## APPEAL SUMMARY

**Status:** Decision Rendered**Appeal ID:** 15833**Project Address:** 817 SW 17th Ave**Hearing Date:** 9/13/17**Appellant Name:** Michelle Schulz**Case No.:** B-016**Appellant Phone:** 503-548-2379**Appeal Type:** Building**Plans Examiner/Inspector:** Kathy Aulwes**Project Type:** commercial**Stories:** 9 **Occupancy:** B, M, A **Construction Type:** 1-B**Building/Business Name:** Press Blocks - Half Block Office**Fire Sprinklers:** Yes - Throughout**Appeal Involves:** Erection of a new structure**LUR or Permit Application No.:** 17-182179-CO**Plan Submitted Option:** pdf [File 1] [File 2] [File 3]**Proposed use:** Office with ground level retail

Opening Protectives  
Appeal

Wood Siding Appeal

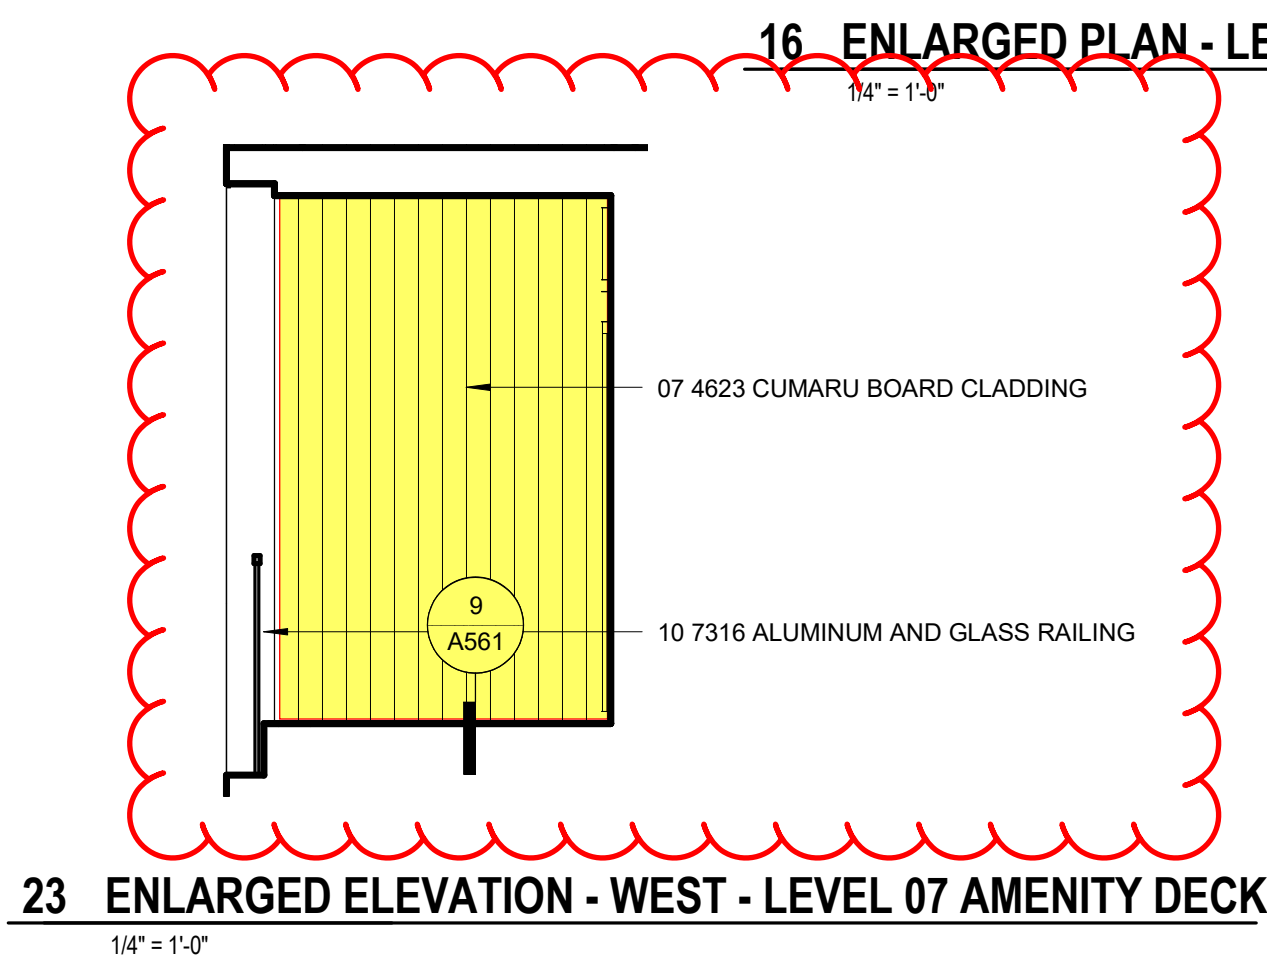
**Proposed Design** The proposed design utilizes FSC certified 1x6 tropical hardwood (Cumaru) as exterior siding at one location on the 7th floor at an exterior terrace. The total area of wood is approximately 199 SF. The wood siding is mounted on fiberglass or galvanized steel Z- furring which is mounted on one layer of exterior gypsum sheathing (Densglass or equivalent) to form a rainscreen. Mineral wool takes up a 2" of a 2 ½" cavity behind the wood siding. The exterior wall assembly is non-combustible throughout.

**3. Cumaru tropical wood Class A cladding at exterior 7th floor amenity space: Granted provided open flame devices are located with a minimum of ten feet separation from the wood cladding.**

36 RCP - LEVEL 01

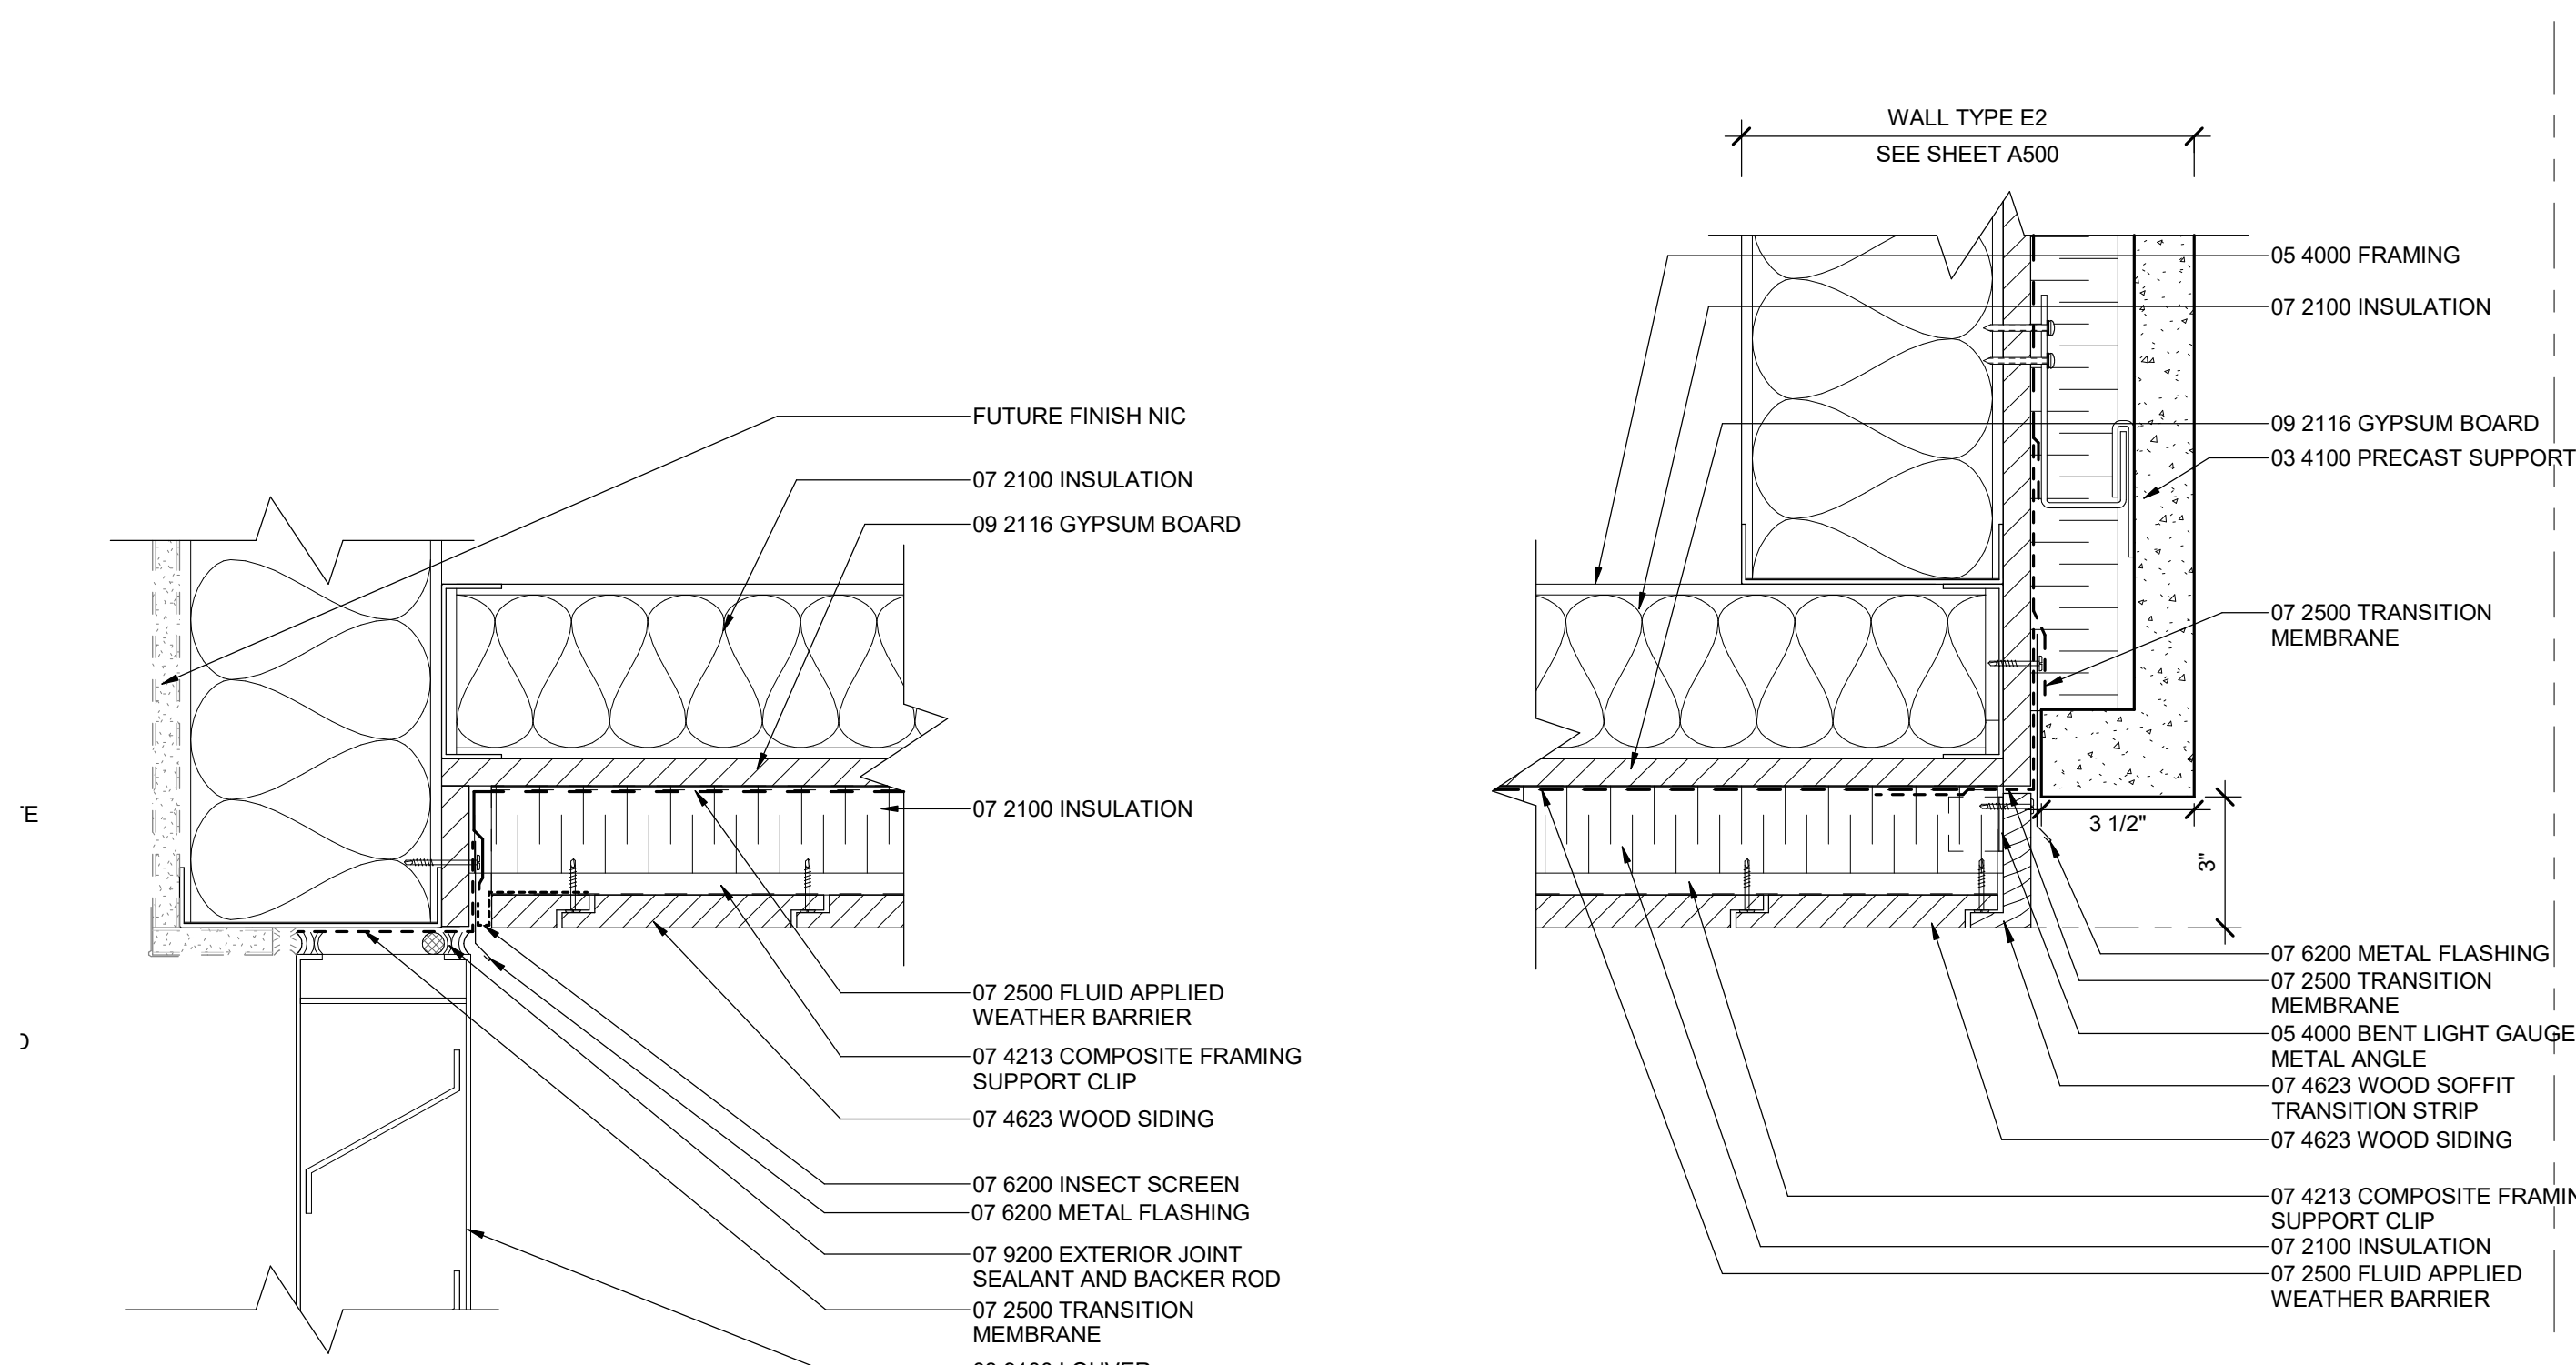
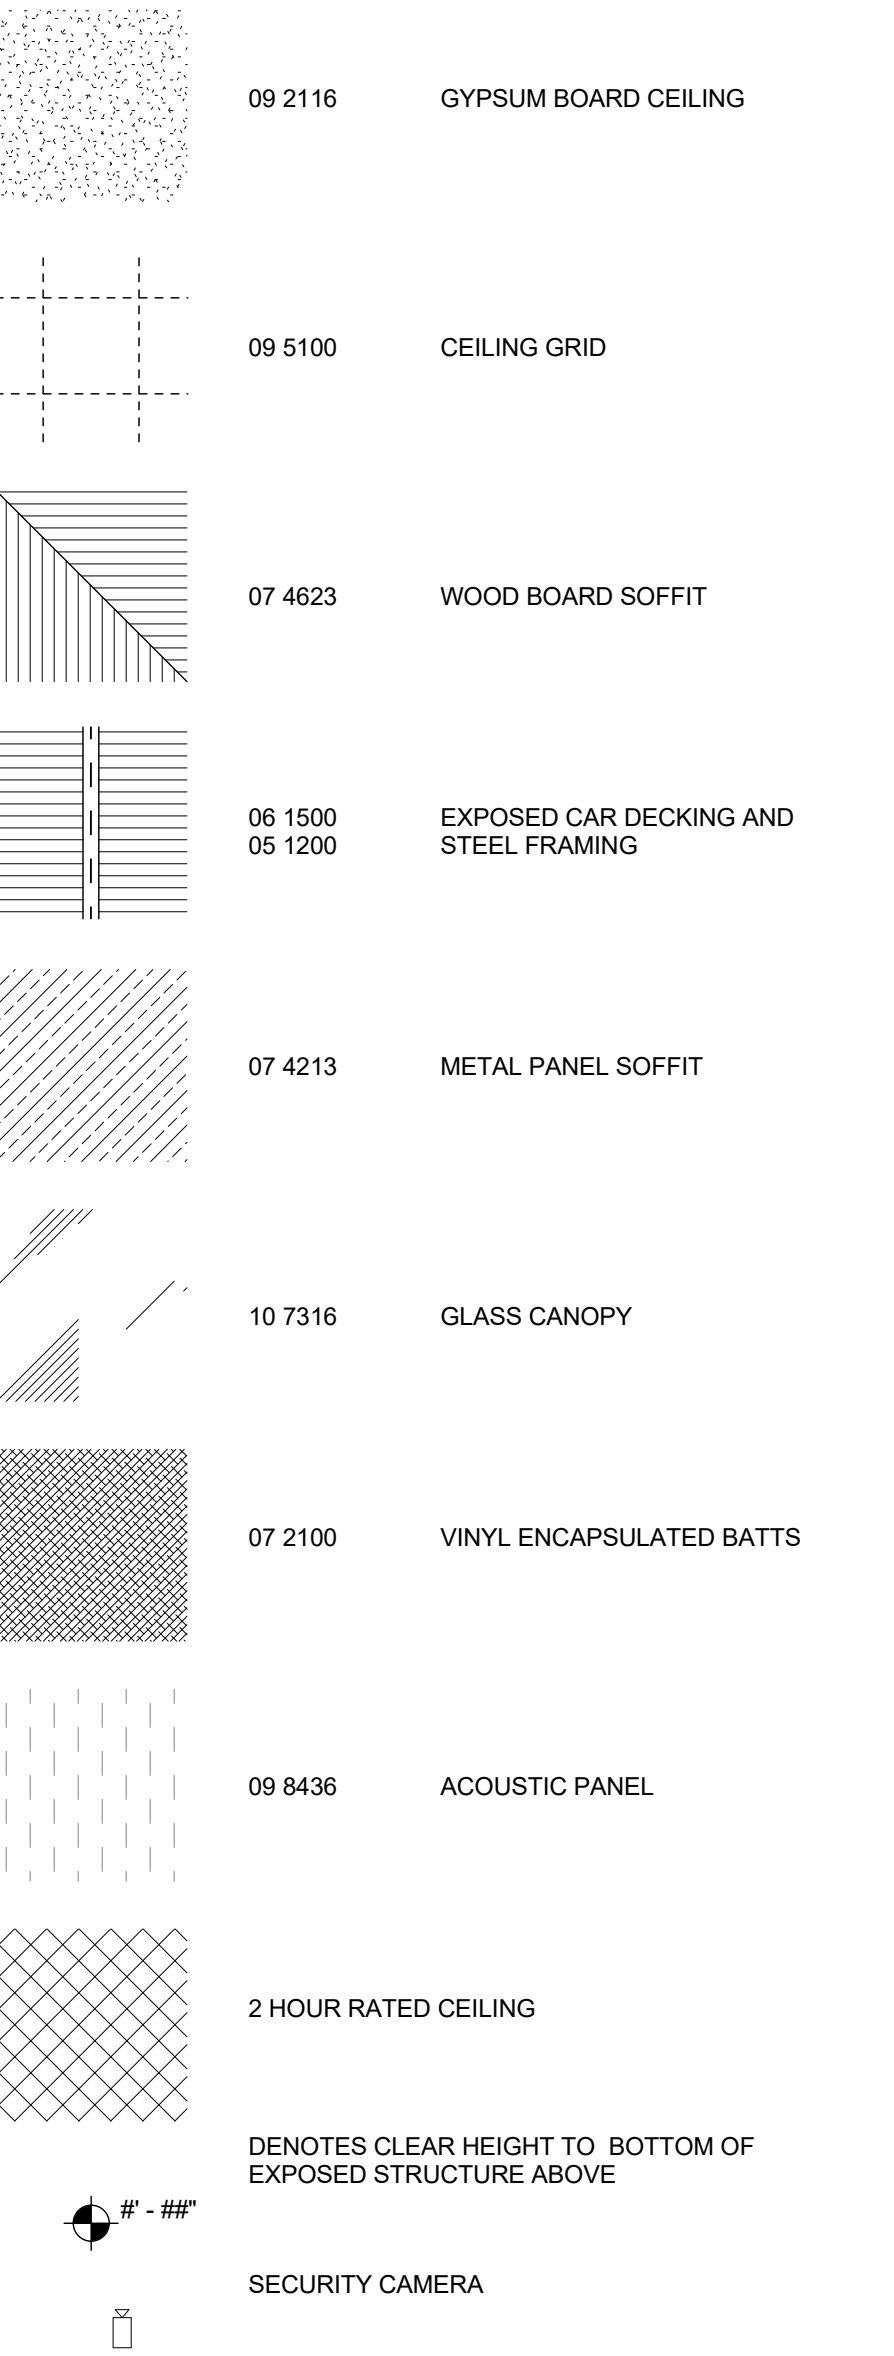
Overhangs located at the ground level and Level 07 are designed using a tropical hardwood material, Cumaru, attached to a non-combustible supporting steel frame which is in turn attached to concrete structural slab.

The primary framing which holds the canopy in place is concrete and the furring is light gauge steel and is non-combustible, so the structural assembly meets the criteria set forth in the OSSC. And the tropical hardwood holds a Class A fire rating and has a flame spread index of not more than 25.

**4. Cumaru tropical wood Class A wood soffit at ground floor and exterior 7th floor amenity space: Granted provided open flame devices are located with a minimum of ten feet separation from the wood soffit.**
